**Re: NOV at Delaware Health Village Phase 1 / Delaware County
Permit #: 4GC02678*AG**

Delaware Health Village Phase 1
Cemetary Annex Milan
August 3, 2009

Figure 5: Sediment run-off into stream

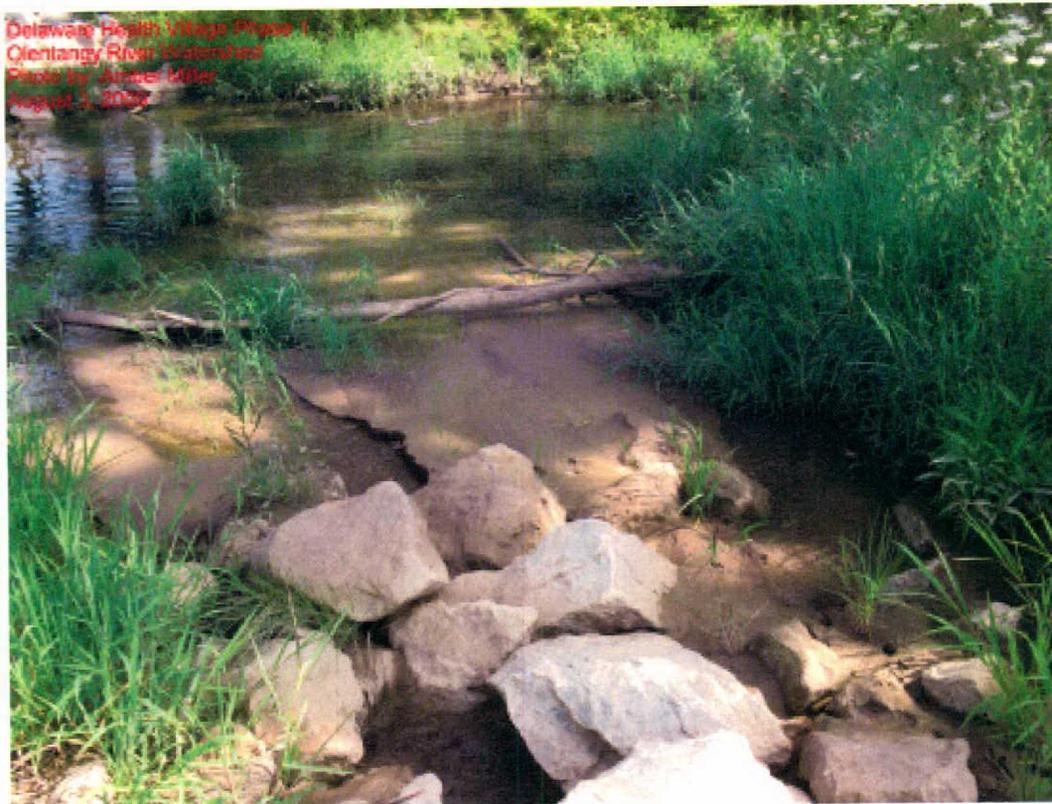
- It appears no corrective actions were implemented to address the deficiencies stated in our June 25, 2009 inspection report. Failure to address these items may result in escalated enforcement by the Agency.
- Upon inspection, sediment controls continue to fail along the northwest corner of the site (See Figure 1, 2, & 3). Corrective actions required within three days from receipt of this letter.
- Failed sediment and erosion controls have contributed to sediment loads to the un-named tributary as depicted in Figures 4 and 5.
